## Note re "Trees and views of St Paul's from Waterlow Park arboricultural impact assessment – update (v2)" from Feb 2022 regarding alternative proposal for pruning lime in section 9

(fig 1) This image was used in the AIA

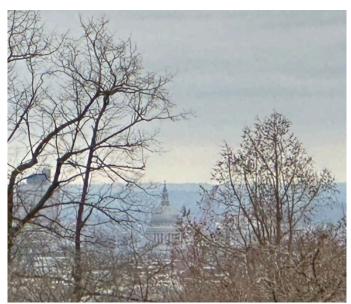
The problem with this proposal, apart from its temporary nature, is that the sight line is unsuitable. This view is only visible when standing at the base of the silver birch near the top path. Take one step to left or right and St Paul's vanishes. From the nearby path which is where a sightline is needed the dome of St Paul's is hidden by the silver birch.
